**Review of IWM study of river
bank erosion management in
Polder 29, Khulna,
Bangladesh**

1221278-000

Client	Project	Reference	Pages
Euroconsult Mott MacDonald	1221278-000	1221278-000-ZWS-0009	4

Figure 2.2. Local river planform development (top) and corresponding interpretation of main bank erosion (bottom) at Chandgar in period 1984-2010 (source: Landsat images at <http://world.time.com/timelapse/>).

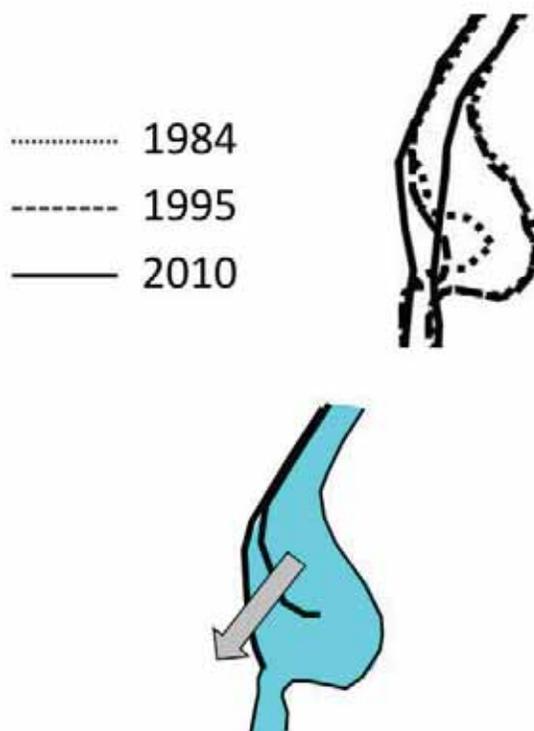
Figure 5.8 shows that no protection is planned along the bank at Jaliakhali. Extrapolation of the interpretation of bankline development in Figure 2.2 of the present document suggests, however, that substantial erosion may be expected there in the near future. This erosion might proceed even further up to the bank East of Baroaria.

Flat slopes and accreting environments offer possibilities for Building-with-Nature-type of solutions. Figure 2.2 of the present document suggests that the wide river area at Chandgar might be suitable for this. It might be possible to dredge the dying bend of this area and to dump the dredged material in the channel along the actively eroding bank. A feasibility study for this solution is recommended.
